STATE OF NORTH CAROLINA
DEPARTMENT OF TRANSPORTATION

Subject: **Modification of Section 404 Nationwide Permits 23 & 33, and Section 401 Water Quality Certification** for the proposed replacement of Bridge Nos. 140 & 147 over Mallard Creek on US 29 in Mecklenburg County, Federal Aid Project No. BRSTP-29(39), Division 10, TIP No. B-4779, Debit \$570 from WBS 38550.1.1.

Reference: Section 404 Nationwide 13, 23 and 33 Permit, Action ID 2012-00782 issued June 6, 2013.
Section 401 Water Quality Certification, DWQ No. 13-0553, issued June 11, 2013.

-L- 23+00.00
WETLAND CROSS SECTION
SITE 3

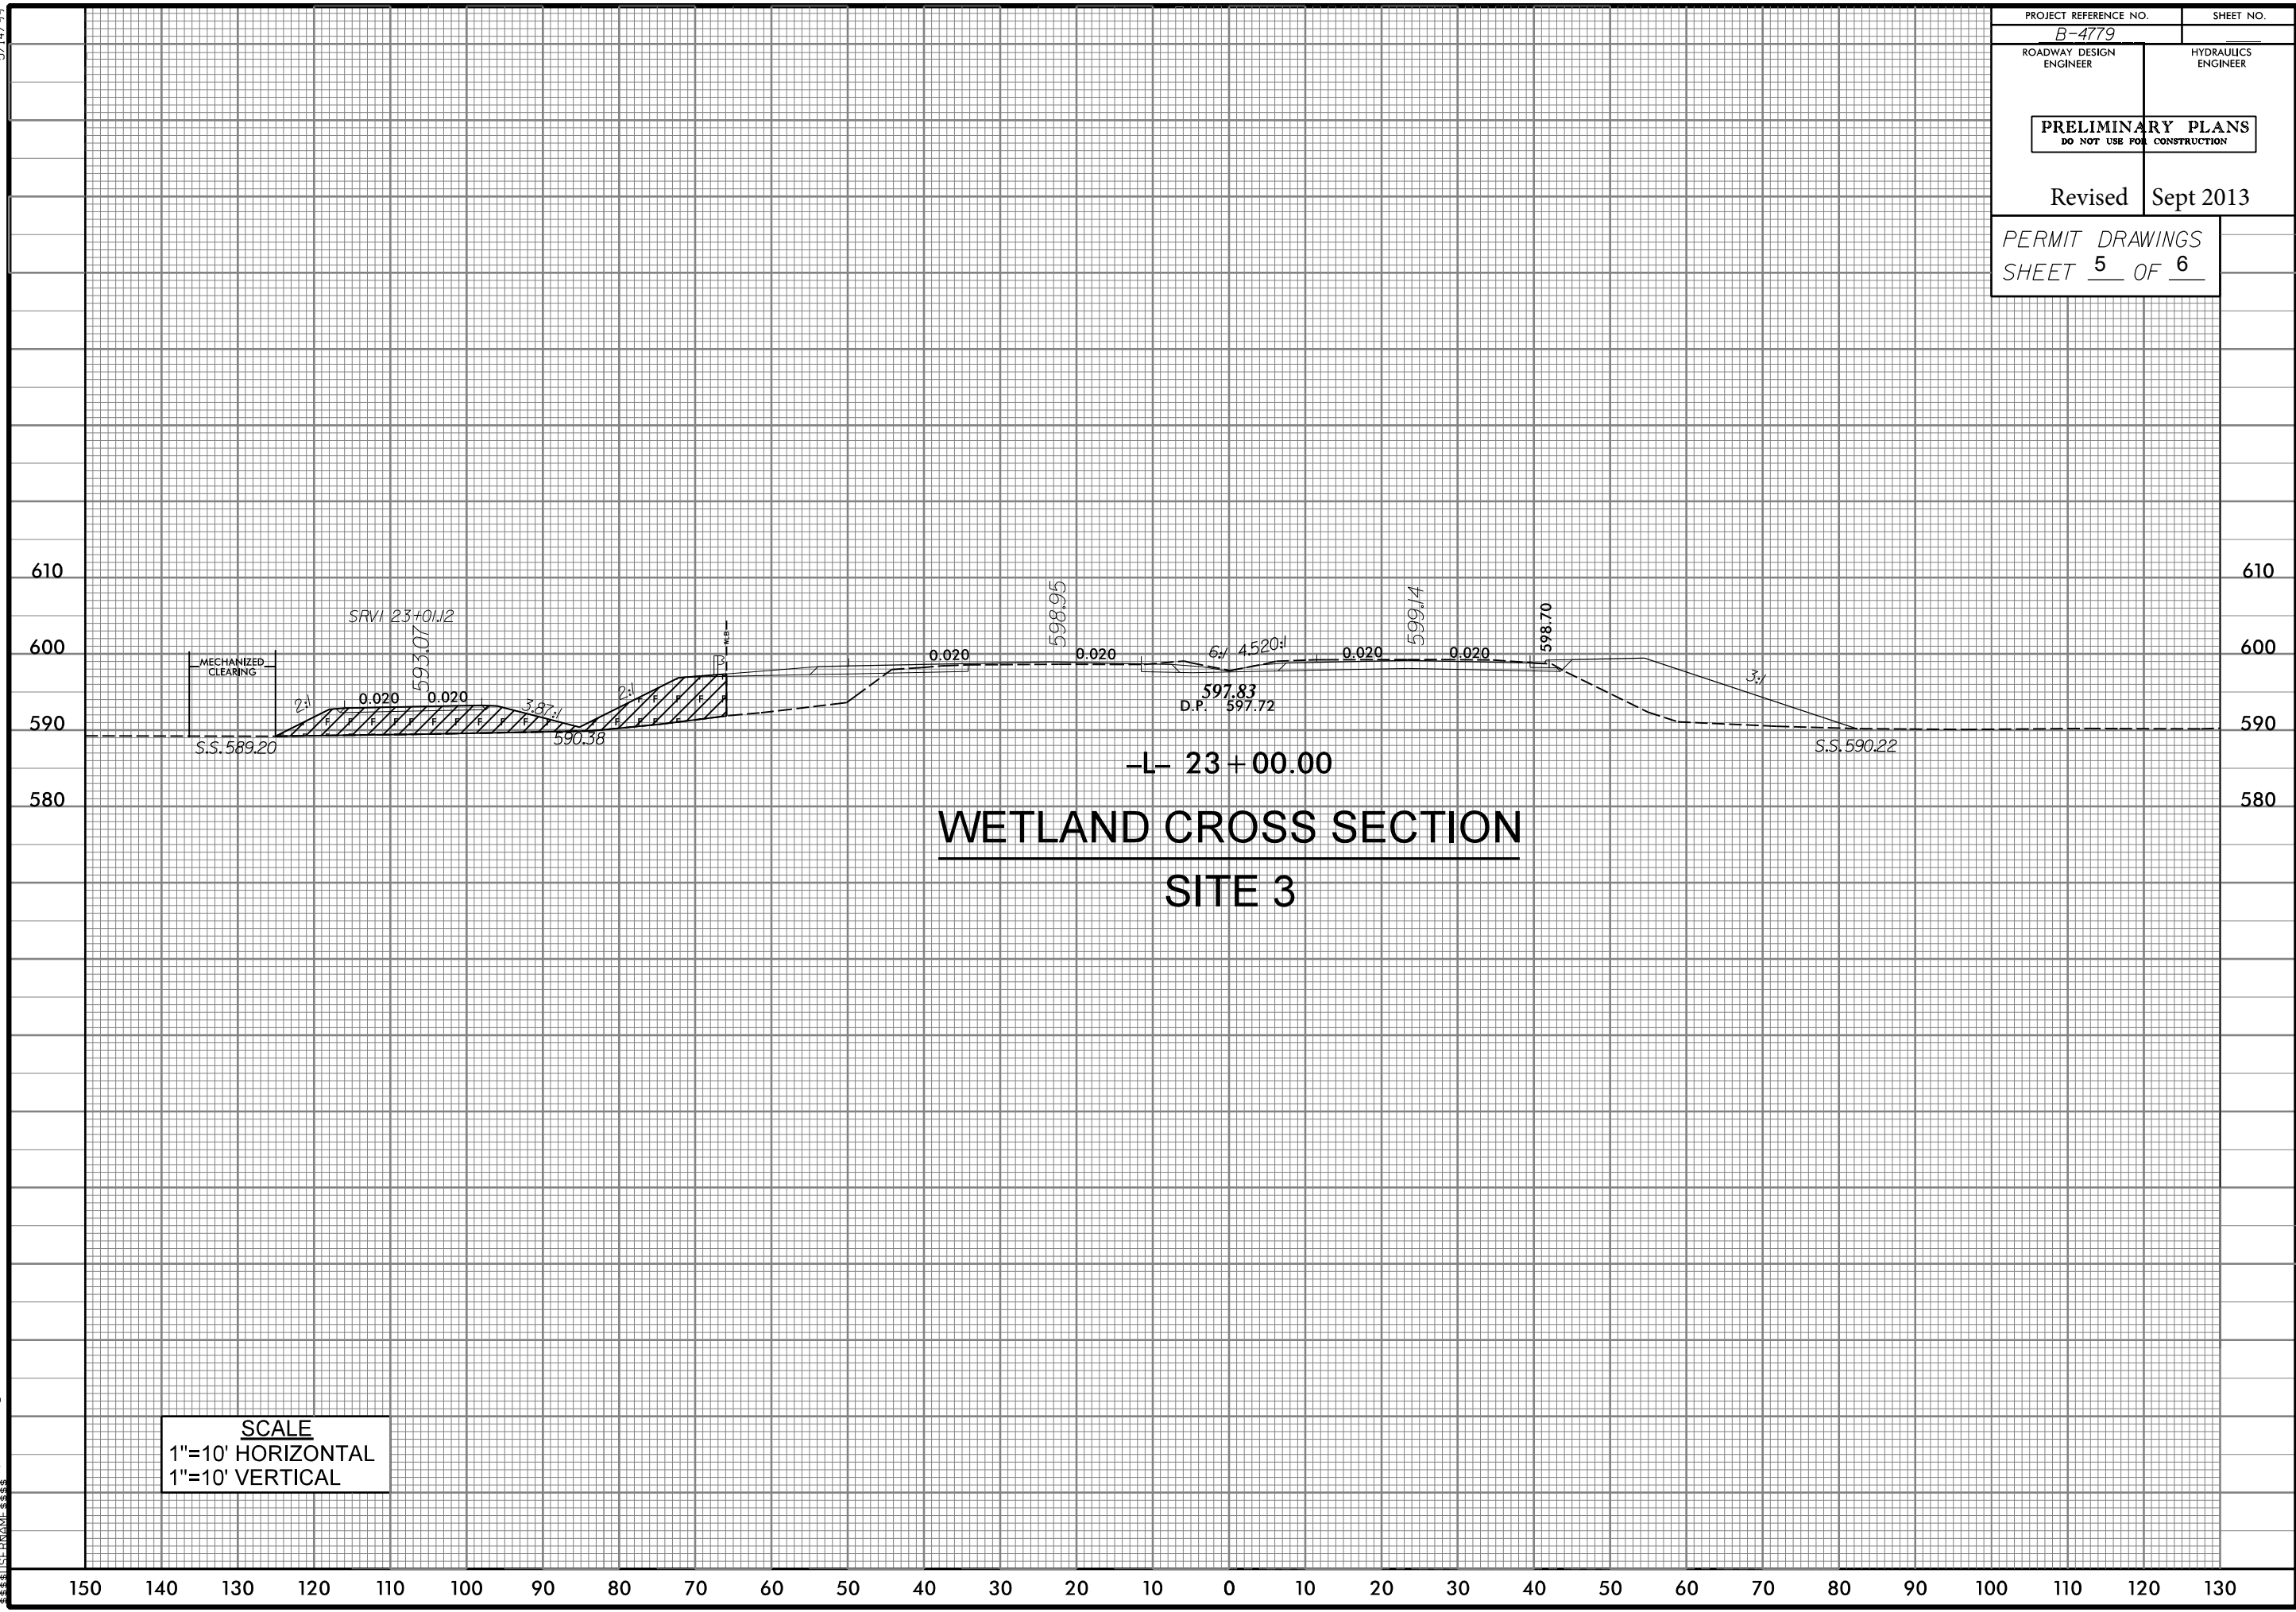
Due to safety concerns with the previous design in regard to pedestrian traffic from the multi-use greenway path under the bridge, the design has been modified to allow pedestrians to safely detour around the work area. The revised design places pedestrians on the service/emergency access road and away from construction activities. This reduces the construction staging area and removes the construction equipment/ pedestrian conflict. However, this shift will result in a net increase in permanent wetland impact of 0.04 acre at Site 3, by way of an additional of 0.06 acre of permanent fill and a reduction of 0.02 acre of mechanized clearing.
